NRC RAI

Evaluate the seismic hazard at your site against current NRC requirements and guidance and, if necessary, update the design basis and structures systems and components important to safety to protect against updated hazards (seismic portion only – of detailed Recommendation 2.1 – Enclosure 7 of SECY-12-0025).

Response L-0998 Outline:

**Levy Nuclear Plant Units 1 and 2
COL Application
Part 2, Final Safety Analysis Report**

Figure RAI L-0998-1: Comparison of hard rock UHRS based on the EPRI-SOG/UCSS model from FSAR with hard rock UHRS using CEUS SSC model.

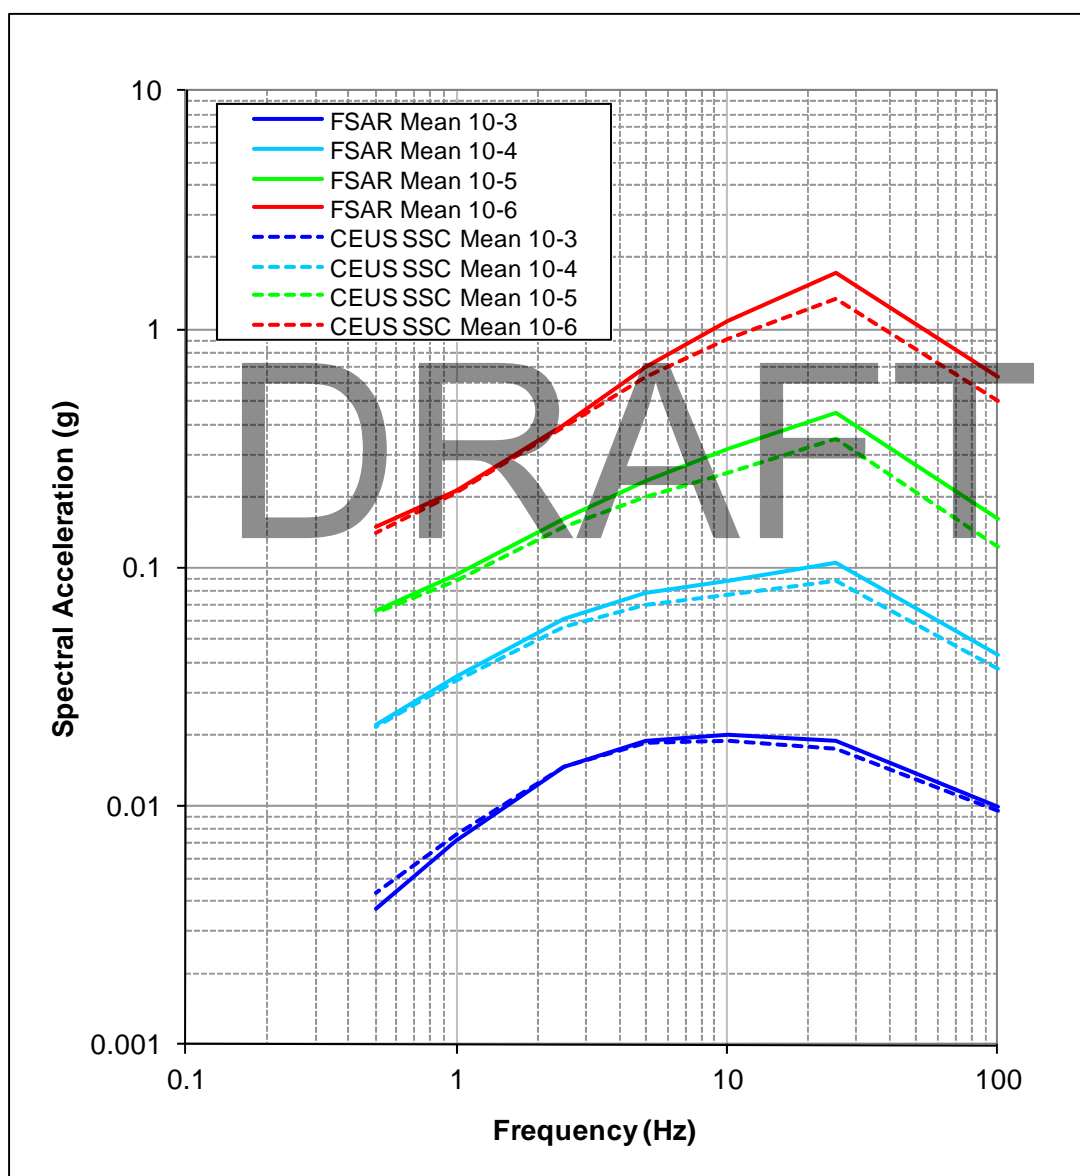
Figure RAI L-0998-1 compares the hard rock UHRS based on the EPRI-SOG/UCSS source model used in the FSAR to the hard rock UHRS based on the CEUS SSC source model. The rock UHRS based on the CEUS SSC model are somewhat lower at spectral frequencies above 2.5 Hz and are similar to the Calculation LNP-0000-X7C-031 results for lower spectral frequencies. The only place where the CEUS SSC model produces higher motions is for the 10^{-3} UHRS at low frequencies. This higher hazard is likely due to the larger maximum magnitudes for the distributed seismicity sources in the CEUS SSC model.

Figure RAI L-0998-2: Comparison of scaled GMRS based on EPRI-SOG/UCSS model with full CAV with the GMRS based on the CEUS SSC model with modified CAV

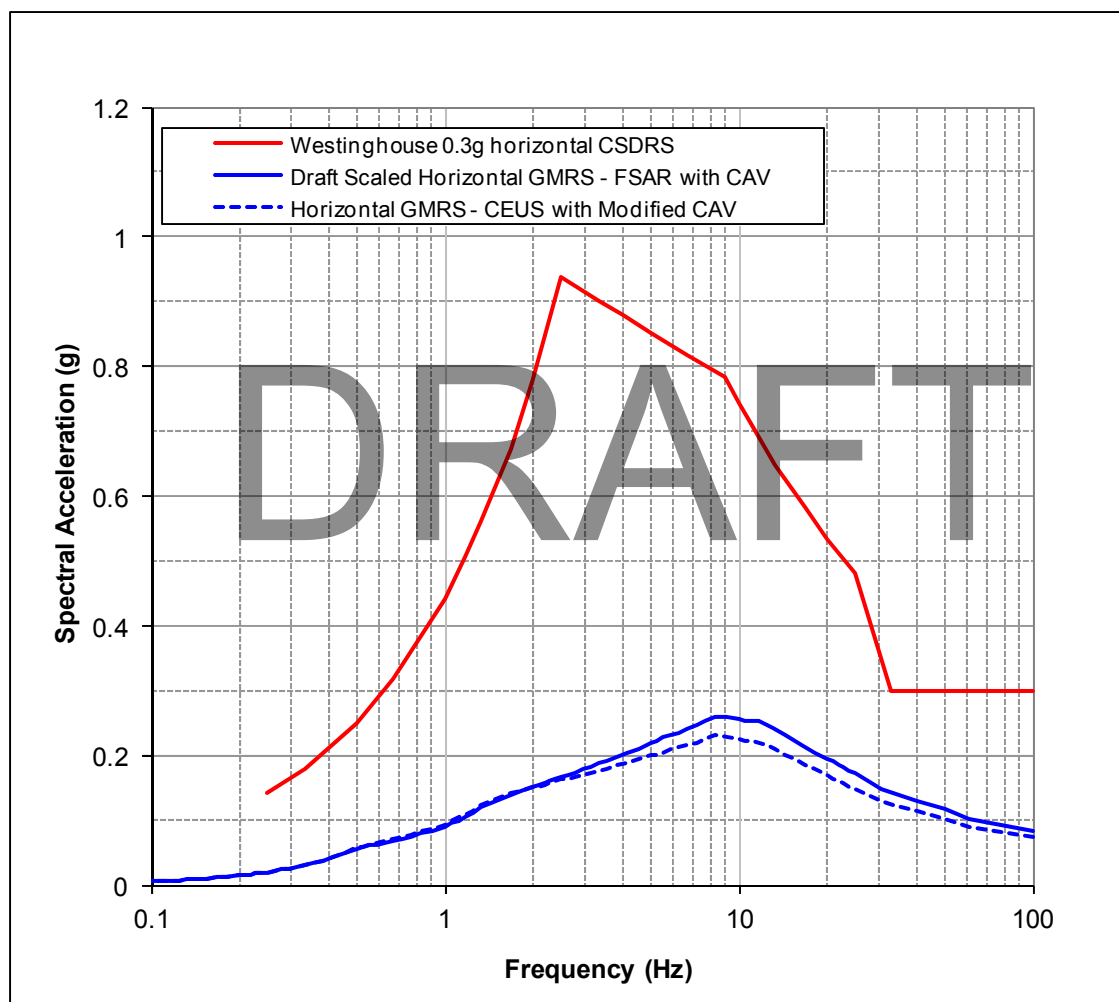
As shown in Figures RAI L-0998-2 and RAI L-0998-3, both the CEUS SSC GMRS and the PBSRS are enveloped by the AP1000 CSDRS. As discussed above, the CEUS SSC LNP site specific floor response spectra (FRS) at the six key locations are bounded by the CSDRS FRS and the maximum bearing pressure is less than the 24 ksf design value. Thus, LNP site unique foundation conditions and CEUS SSC ground motions do not lower the High Confidence Low Probability of Failure (HCLPF) values calculated for the certified design.

Figure RAI L-0998-2 compare the scaled GMRS based on the EPRI-SOG/UCSS model with full CAV with the GMRS based on the CEUS SSC model with modified CAV. The scaled GMRS based on the CEUS SSC is lower than the GMRS based on the EPRI-SOG/UCSS model with full CAV except for frequencies between 0.2 and 2 Hz where the maximum increase is approximately 4 percent at 1 Hz.

Figure RAI L-0998-3: Comparison of PBSRS based on EPRI-SOG/UCSS model with full CAV with the PBSRS based on the CEUS SSC model with modified CAV

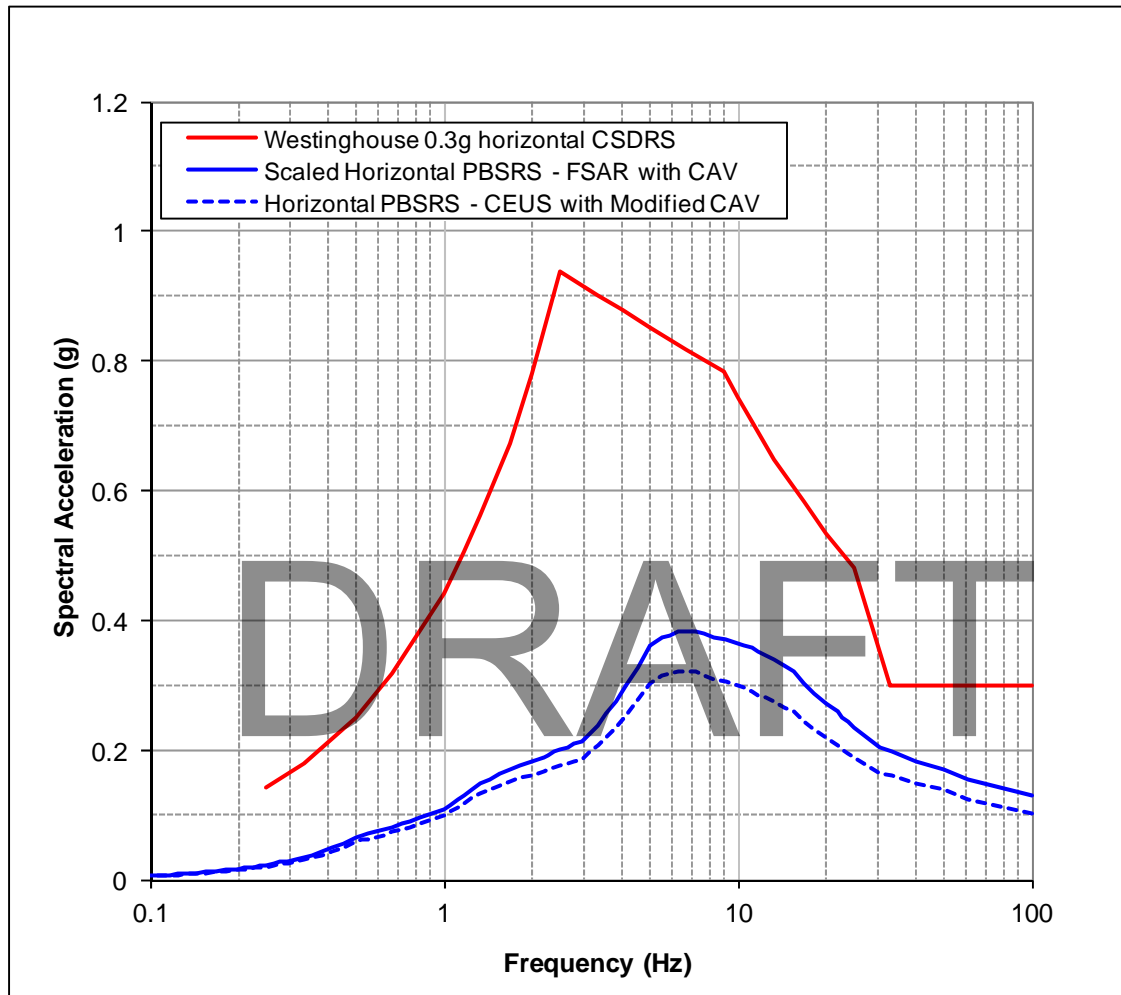
The EPRI SOG scaled finished grade PBSRS was used to show that there is no interaction between the adjacent AB, TB, and RB with the NI. As shown in Figure RAI L-0998-3, the CEUS SSC finished grade PBSRS is enveloped by the EPRI SOG scaled finished grade PBSRS. Thus, the conclusions that there is no interaction between the adjacent AB, TB, and RB with the NI is valid for the LNP site ground motions based on the CEUS SSC model.

Figure RAI L-0998-3 compares the scaled PBSRS based on the EPRI-SOG/UCSS model with full CAV with the PBSRS based on the CEUS SSC model with modified CAV. The PBSRS based on the CEUS SSC model is enveloped by the scaled PBSRS based on the EPRI-SOG/UCSS model at all frequencies,

adjacent AB, TB, and RB, earthquake induced cyclic stresses in the soil column were based on ground motions consistent with the finished grade scaled PBSRS. As shown in Figure RAI L-0998-3, the CEUS SSC PBSRS is enveloped by the EPRI SOG scaled PBSRS. Thus, the liquefaction evaluations based on the EPRI SOG LNP ground motions bound those from the CEUS SSC ground motions.

As shown in Figure RAI L-0998-3, the CEUS SSC PBSRS is enveloped by the EPRI SOG scaled PBSRS used for site specific displacement of the Annex Building, Turbine Building, and the Radwaste Building as described in Subsections 3.7.2.8.1, 3.7.2.8.2, and 3.7.2.8.3. Thus the conclusions in these subsections of no seismic interaction between the Annex Building, Turbine Building, and Radwaste Building and the NI is valid for the LNP site ground motions based on the CEUS SSC model.

Figure RAI L-0998-4: Comparison of 10^{-5} surface UHRS based on EPRI-SOG/UCSS model with full CAV with the 10^{-5} surface UHRS based on the CEUS SSC model with modified CAV.

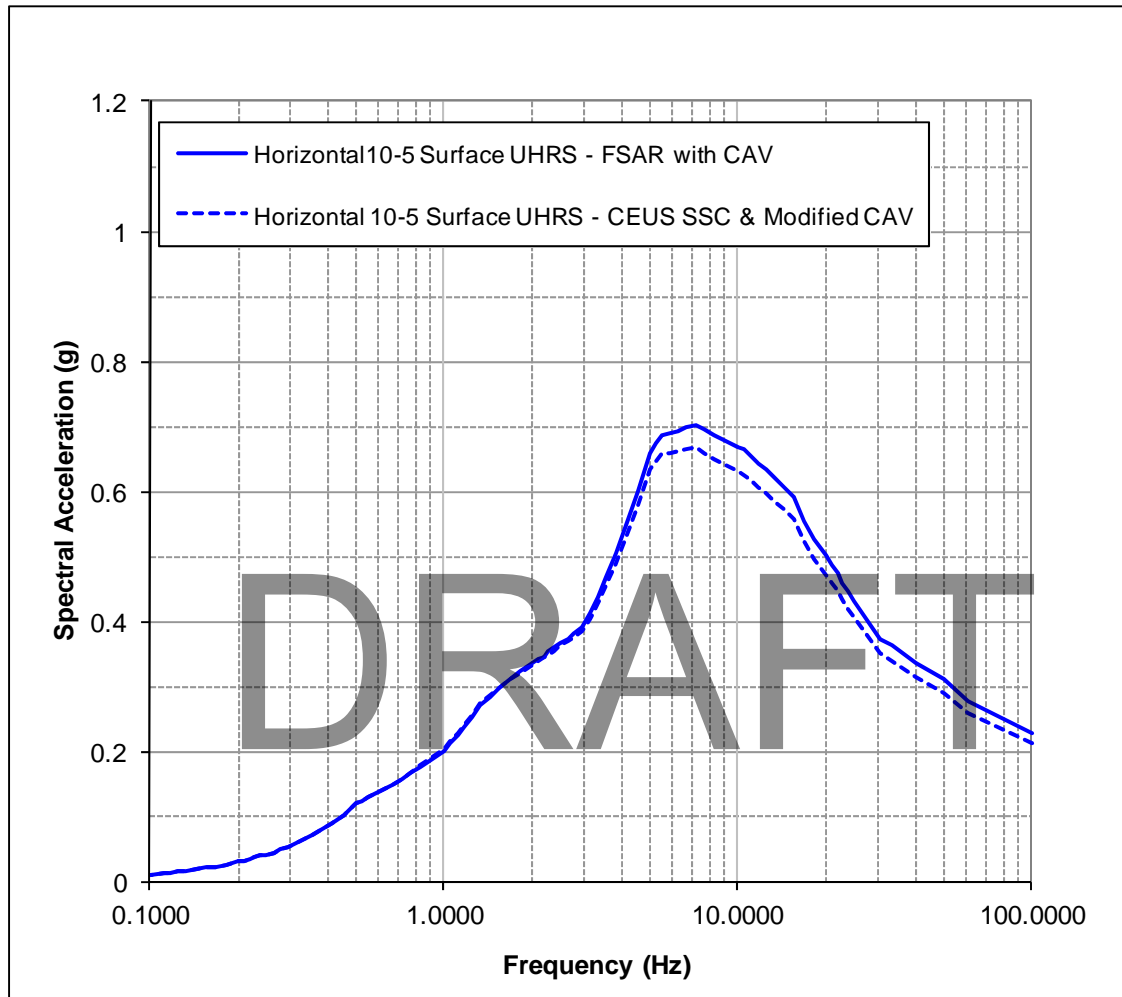
Figure RAI L-0998-4 compares the 10^{-5} UHRS based on the EPRI-SOG/UCSS model with full CAV with the 10^{-5} UHRS based on the CEUS SSC model with modified CAV. The 10^{-5} UHRS based on the CEUS SSC model is enveloped by the scaled 10^{-5} UHRS based on the EPRI-SOG/UCSS model at all frequencies except in the frequency range of 0.5 to 1.7 Hz where the 10^{-5} UHRS based on the CEUS SSC model is up to 1.7 percent higher.

Figure RAI L-0998-5: Comparison of RB FIRS (+11 ft) based on EPRI-SOG/UCSS model with full CAV with the RB FIRS based on the CEUS SSC model with modified CAV

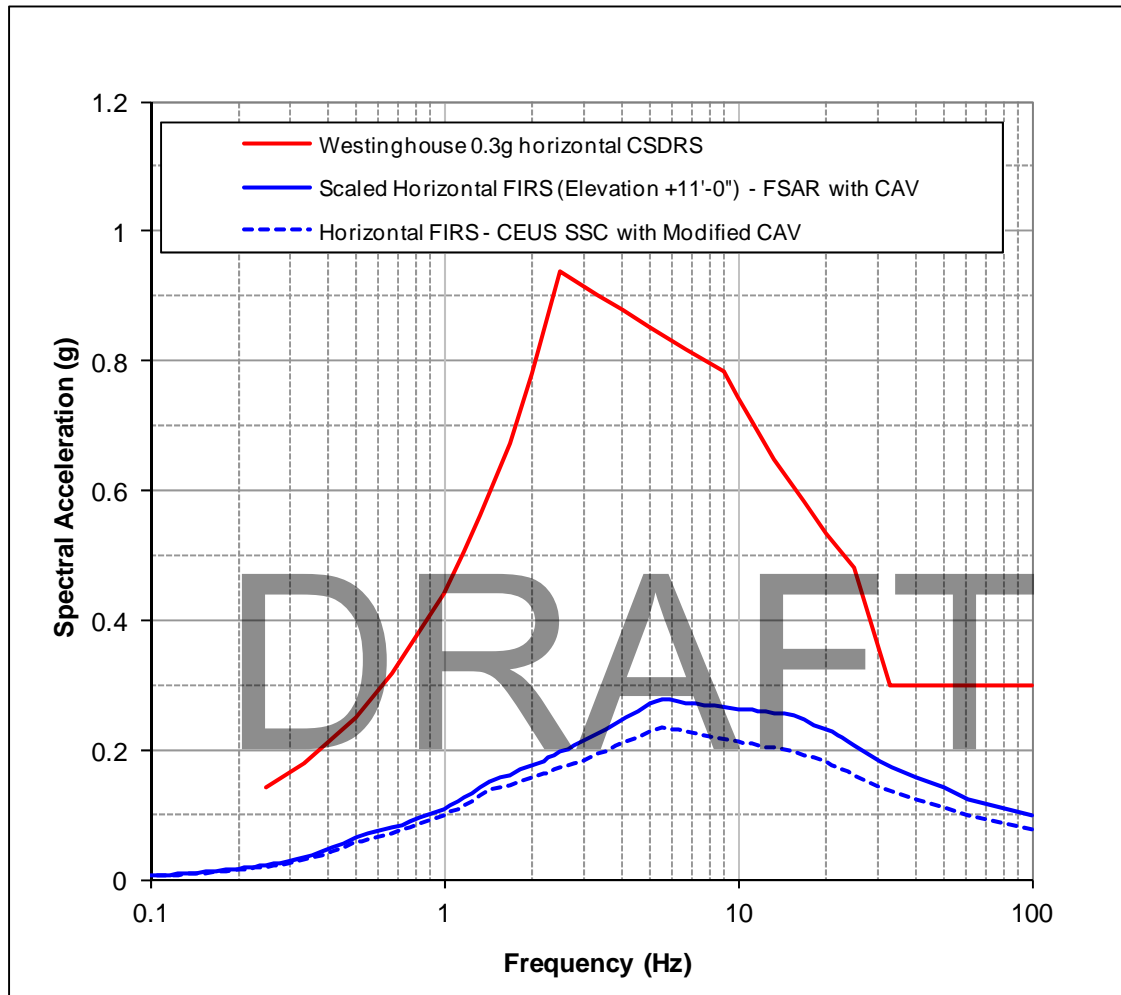
The scaled EPRI SOG scaled FIRS (EL +11 ft.) was the input ground motion for the LNP site specific SSI analysis. As shown in Figure RAI L-0998-5, the CEUS SSC FIRS (EL +11 ft.) is enveloped by the EPRI SOG scaled FIRS (EL +11 ft.). Thus, the conclusions of the LNP site specific SSI analysis that the LNP floor response spectra (FRS) at the six key locations are bounded by the CSDRS FRS and the maximum bearing pressure is less than the 24 ksf design value are also valid for the for the LNP site ground motions based on the CEUS SSC model.

Figure RAI L-0998-5 compares the scaled Reactor Building FIRS based on the EPRI-SOG/UCSS model with full CAV with the Reactor Building FIRS based on the CEUS SSC model with modified CAV. The Reactor Building FIRS based on the CEUS SSC model is enveloped by the scaled Reactor Building FIRS based on the EPRI-SOG/UCSS model at all frequencies.

As shown in Figure RAI L-0998-5, the CEUS SSC FIRS is enveloped by the EPRI SOG scaled FIRS used for site specific soil structure interaction analysis described in Subsection 3.7.2.4.1. Because the CEUS SSC vertical FIRS scales directly with the CEUS SSC horizontal FIRS and the V/H ratios are unaffected, the CEUS SSC FIRS will also be enveloped by the scaled EPRI SOG vertical FIRS. Thus, the conclusions of the soil structure analysis presented in Subsections 3.7.2.4.1.5 and 3.7.2.4.1.6 are valid for the LNP site ground motions based on the CEUS SSC model.

Figure RAI L-0998-6: Comparison of the horizontal 10^{-5} UHRS at finished grade developed using the EPRI-SOG/UCSS source model presented in the FSAR with 1.67 x the GMRS developed using the CEUS SSC model with modified CAV.

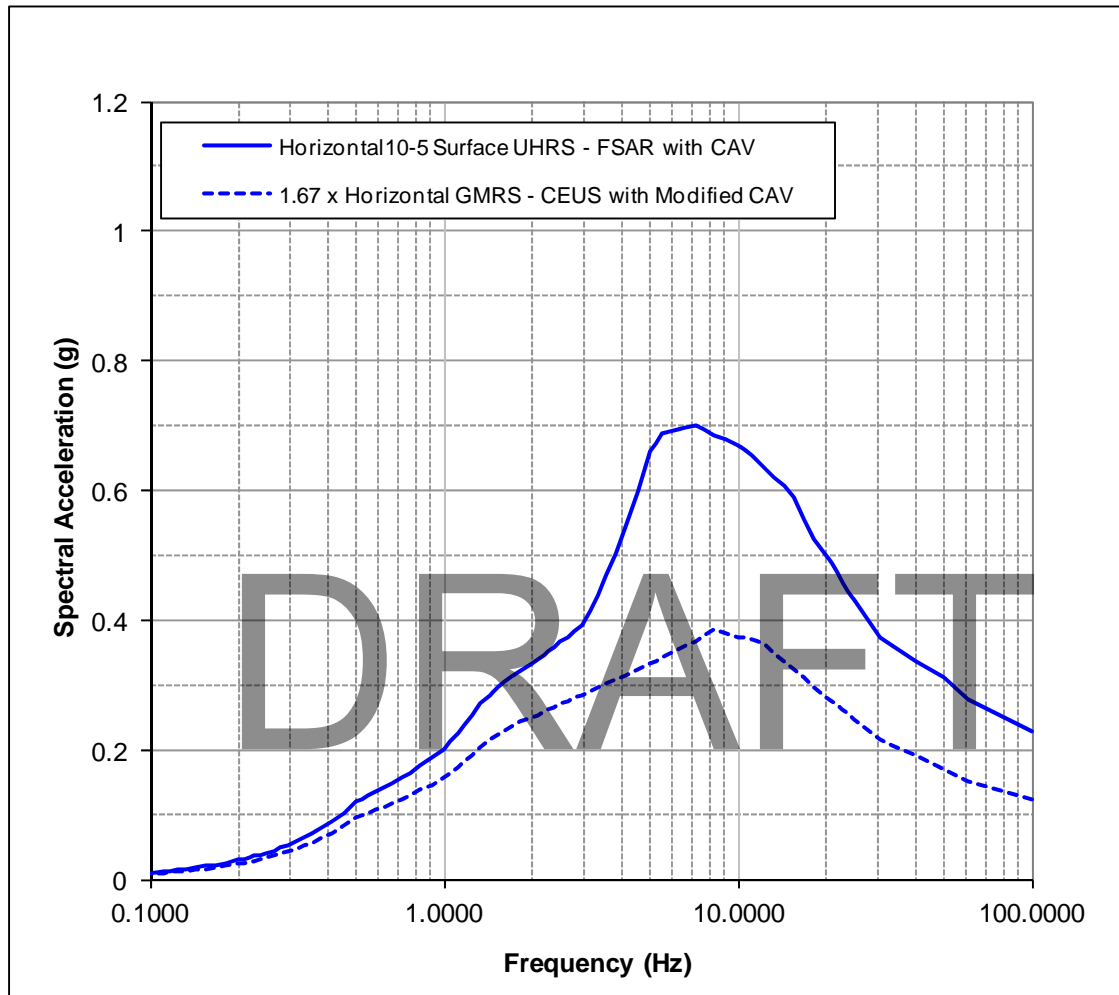
To evaluate the HCLPF liquefaction potential of soils under the adjacent AB, TB, and RB, earthquake induced cyclic stresses in the soil column based on ground motions consistent with the EPRI SOG finished grade 10^{-5} UHRS were used. As shown in Figures RAI L-0998-6 and RAI L-0998-7, 1.67*GMRS and 1.67*PBSRS developed using the CEUS SSC methodology and modified CAV filter are enveloped by the EPRI SOG finished grade 10^{-5} UHRS. Thus, HCLPF capacity for no liquefaction potential of soil under the AB, TB, and RB exceeds the 1.67*GMRS goal for the plant level HCLPF for the CEUS SSC ground motions.

To calculate the HCLPF capacity for seismic interaction between the AB, TB, and RB and the NI, the AB, TB, and RB displacements relative to the NI were calculated using the EPRI SOG finished grade 10^{-5} UHRS. As shown in Figures RAI L-0998-6 and RAI L-0998-7, 1.67*GMRS and 1.67*PBSRS developed using the CEUS SSC methodology and modified CAV filter are enveloped by the EPRI SOG finished grade 10^{-5} UHRS. Thus, HCLPF capacity for no seismic interaction between the AB, TB, and RB and the NI exceeds the 1.67*GMRS goal for the plant level HCLPF for the CEUS SSC ground motions.

Figures RAI L-0998-6 and -7 compare the 10^{-5} horizontal surface UHRS based on the EPRI-SOG/UCSS model with full CAV to 1.67 x the GMRS and PBSRS, respectively, based on the CEUS SSC model with modified CAV. The 1.67 x the GMRS and PBSRS based on the CEUS SSC model with modified CAV are enveloped by the 10^{-5} horizontal surface UHRS based on the EPRI-SOG/UCSS model with full CAV.
